ANNEXURE 14

Copy Of Applicants Response To Further Information Request By Selwyn District Council

**PC100028: DENWOOD TRUSTEES LIMITED (DTL) PRIVATE PLAN CHANGE:
FURTHER INFORMATION RESPONSE**

**RE: ADDITIONAL TRAFFIC ASSESSMENT INFORMATION FOR COUNCIL FOR
PROPOSED PLAN CHANGE 28 TO SELWYN DISTRICT COUNCIL – DENWOOD
TRUSTEES PROPERTY**

Appendix 1.0: Map of Lincoln

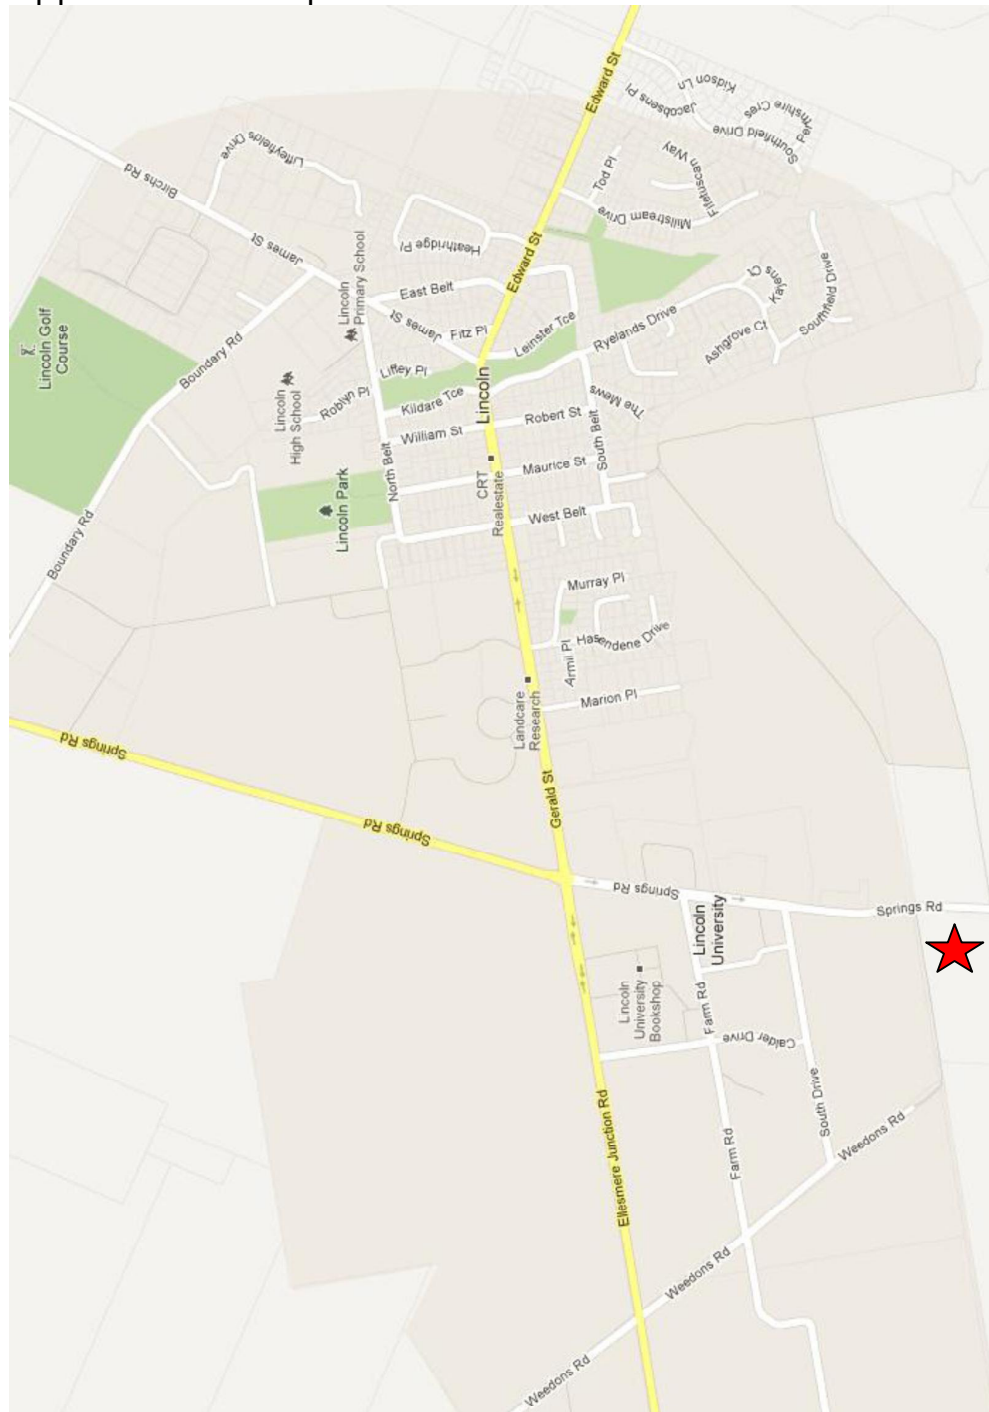
1. *Clauses 7 – 21; these clauses refer to many roads within the area. Some are shown on the existing maps within the report where others are not. Again for clarity it would ideal to provide an overall plan/map of Lincoln showing all these roads mentioned in the report. It could also include the bus routes and stops in relation to the proposal.*

A map has been attached (as Appendix 1.0) to this letter which shows the main roads within the Lincoln Township area. The metro bus route map has also been attached (as Appendix 2.0) and this shows the location of bus stops. It is noted that currently (following changes since the February earthquakes) the 518 route previously mentioned does not appear to be operating. This is also shown online at: <http://www.metroinfo.org.nz/limited-services.html>.

Appendix 3.0: CAS Crash Report and Collision Diagram (2001-2011).

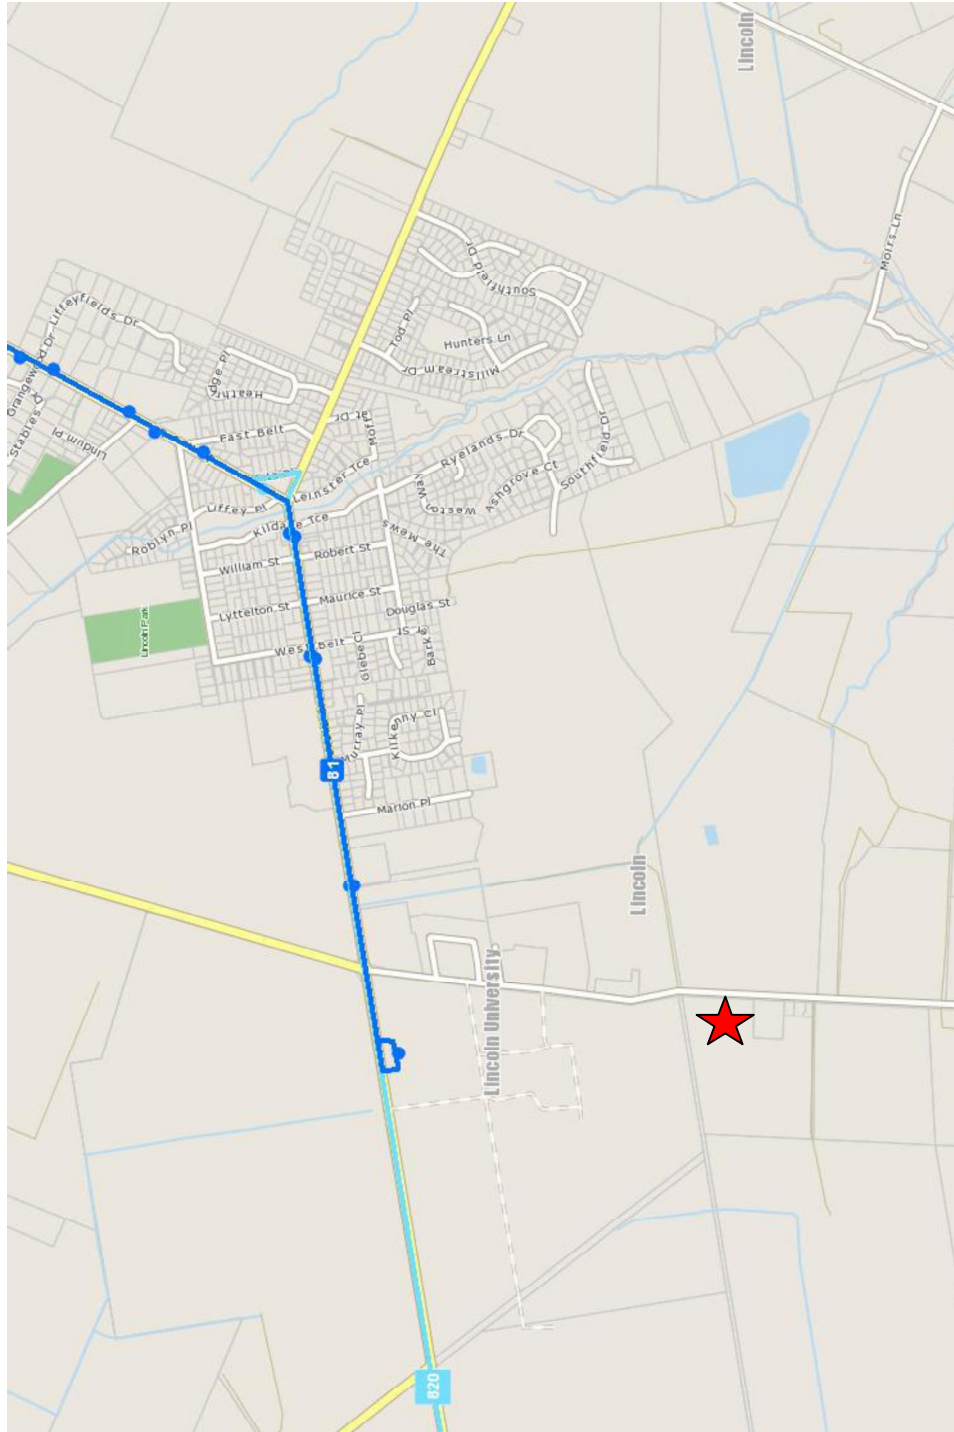
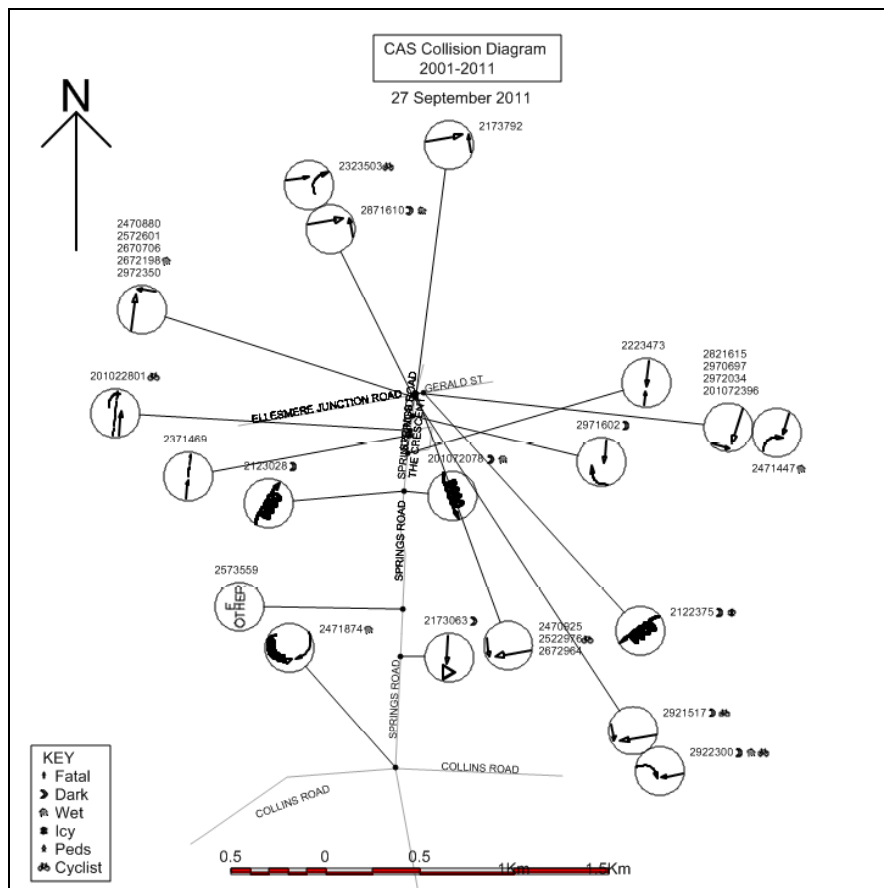
3. *Clause 17; There is no summary of the number of crashes or type over the 5 yr period only a diagram. For instance how many involved injury? It is recommended this be added. The data output from CAS could be added in an appendix. This is common practice. Also the existing diagram has no key.*

An updated search of the CAS database (over 10 years from 2001 to 2011) has been undertaken with the Crash report and Collision Diagram attached (as Appendix 3.0) to this letter. The following points are noted:

- There were 28 reported crashes over the 10 year search period, 18 of these occurred at the Springs road, Ellesmere junction road, Gerald Street roundabout.
- None of the reported crashes resulted in fatal or serious injuries, nine of the reported crashes resulted in minor injuries.
- The type of crashes occurring at the Springs Road, Ellesmere Junction Road, Gerald Street roundabout were typical of that which generally occurs at roundabouts (failure to give way) and suggest driver error rather than any inherent geometric, design or layout flaws.
- There were no crash trends present in the remainder of the crashes with most related to discrete events such as icy roads, fog/mist, stray animals, over-dimension load, fatigue, alcohol.

The updated crash statistics no not change any of the previous conclusions reached.
